**Proposed Lower Ground Floor Plan**

Planning - New French Door  
 Lower Ground Floor Plan  
 1:100@A3 January 2015

**FZA64-P100(A)**

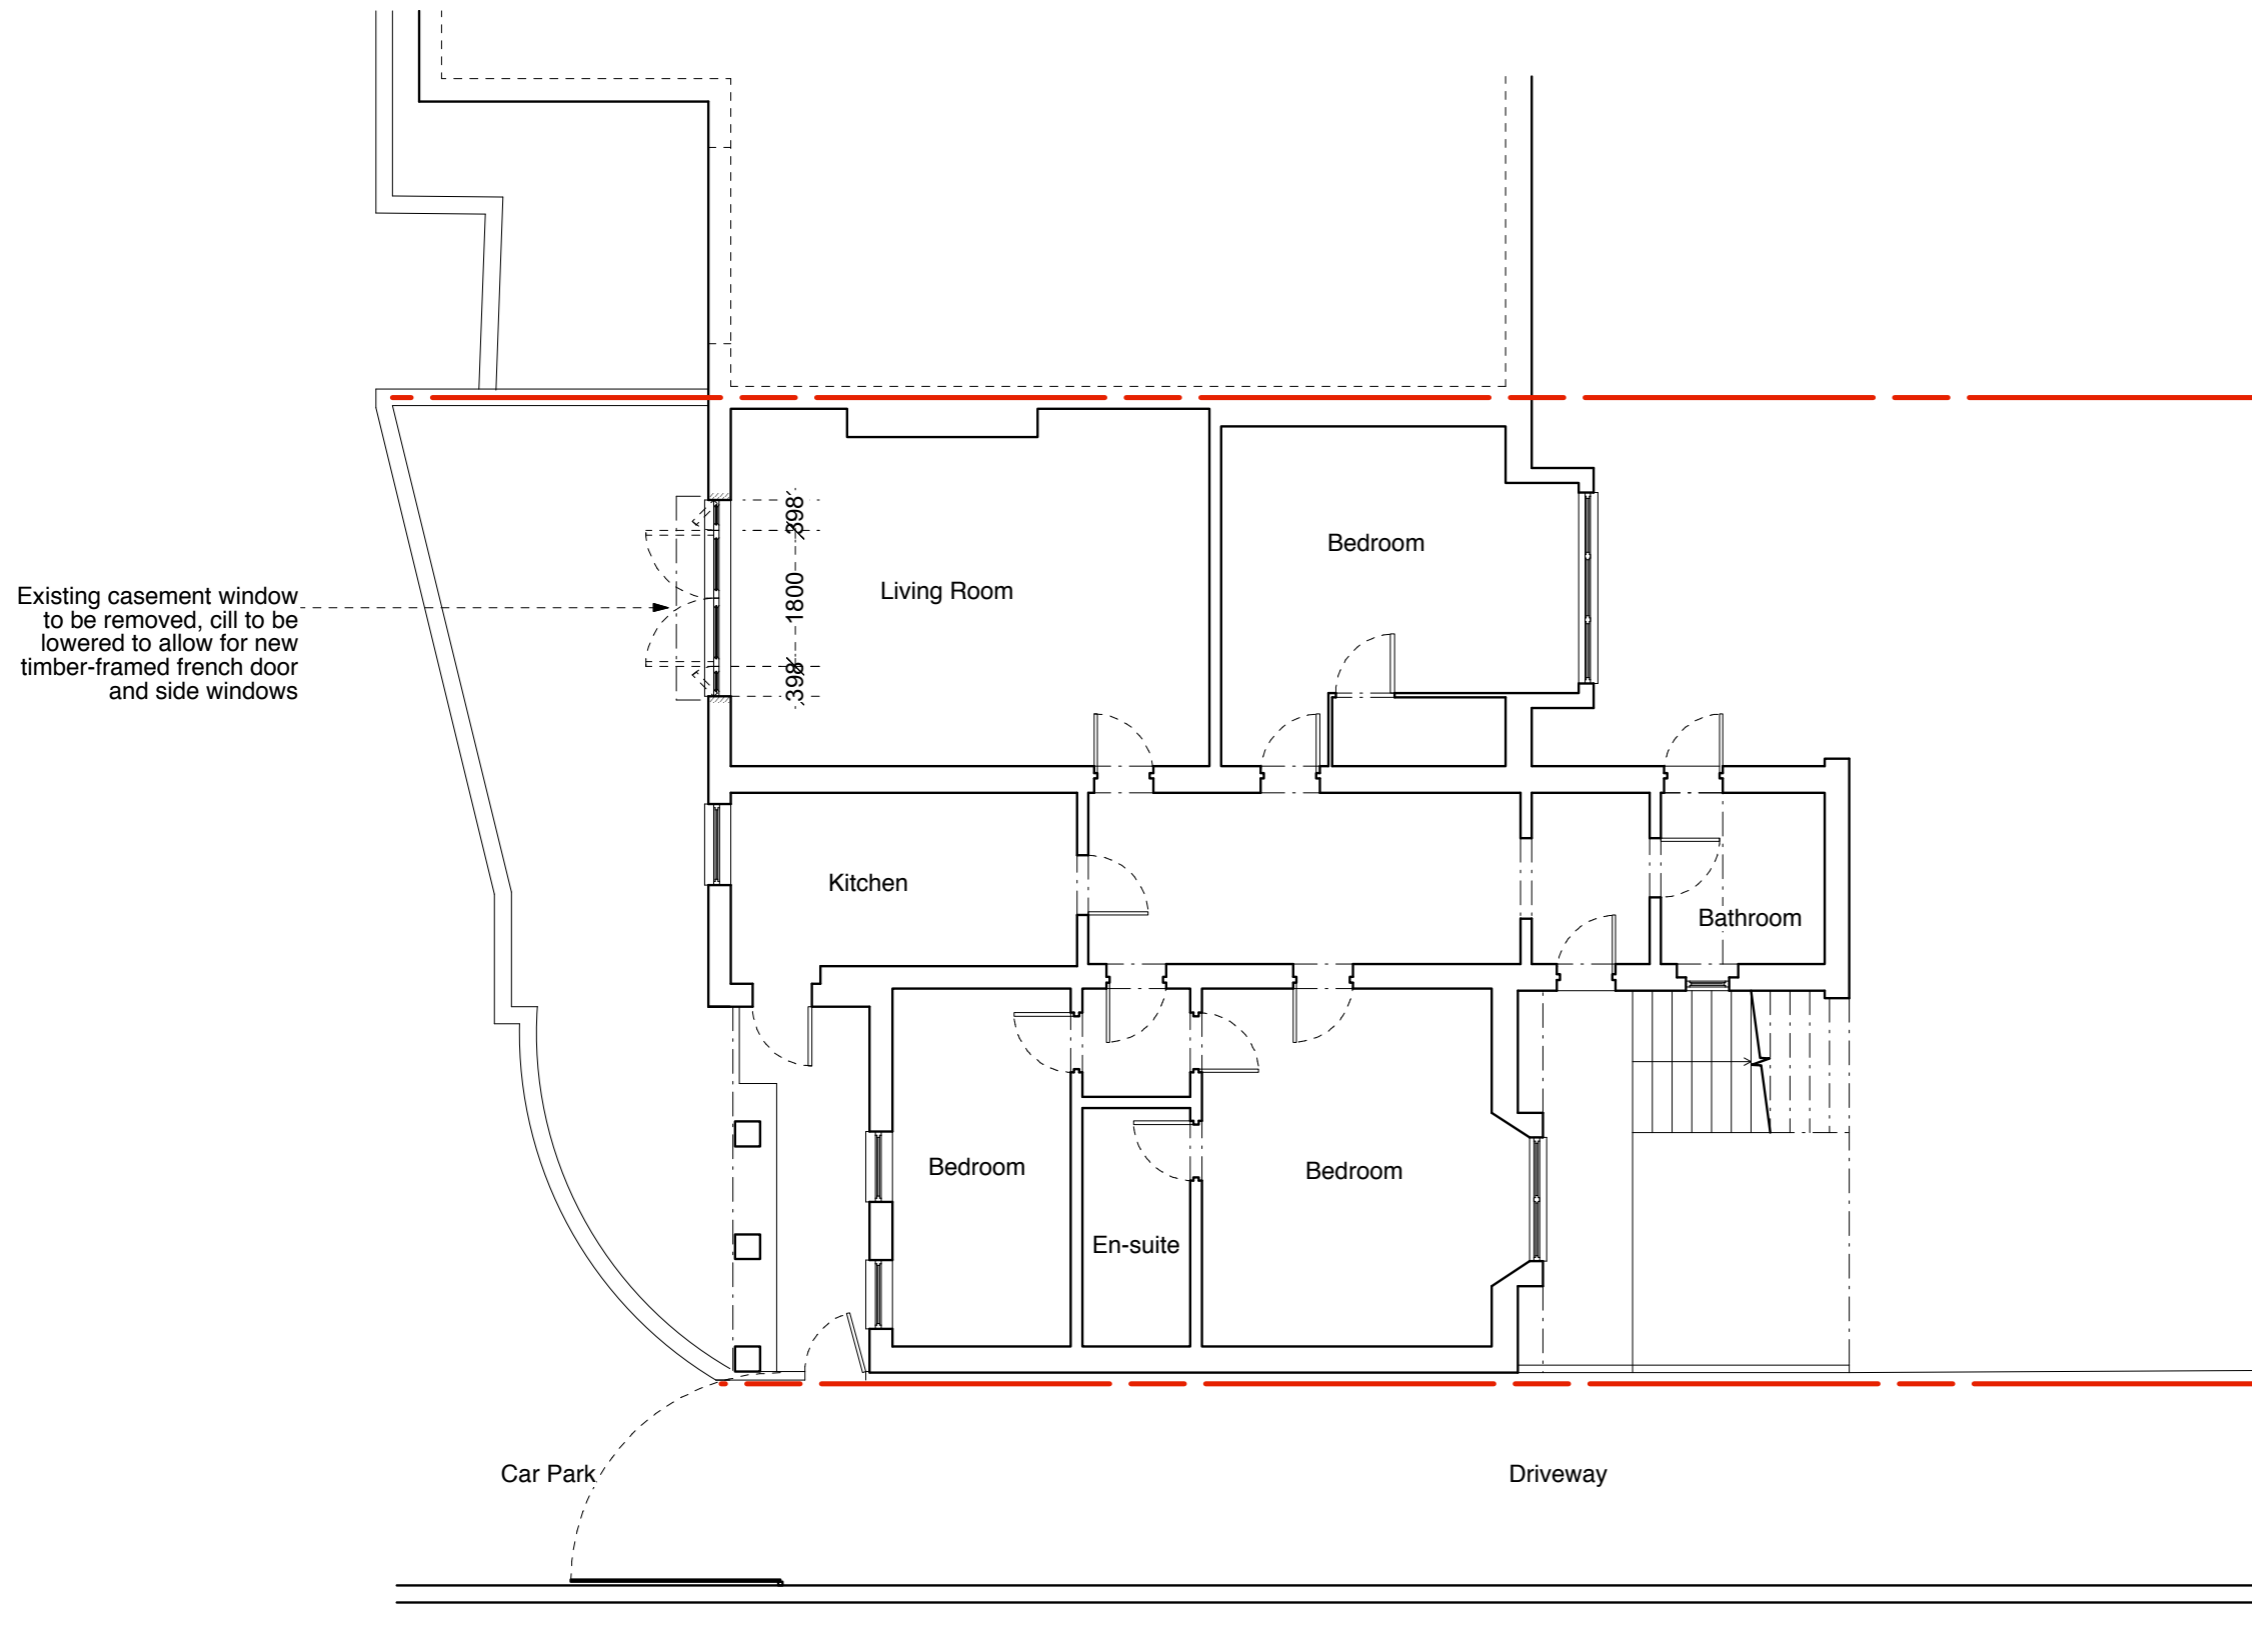
(A): French door changed to painted timber (23.02.15/AL)  
 (L): Issued for Planning (15.01.15/AL)  
 Revision: Information (date/drawn by)

Existing casement window  
 to be removed, cill to be  
 lowered to allow for new  
 timber-framed french door  
 and side windows
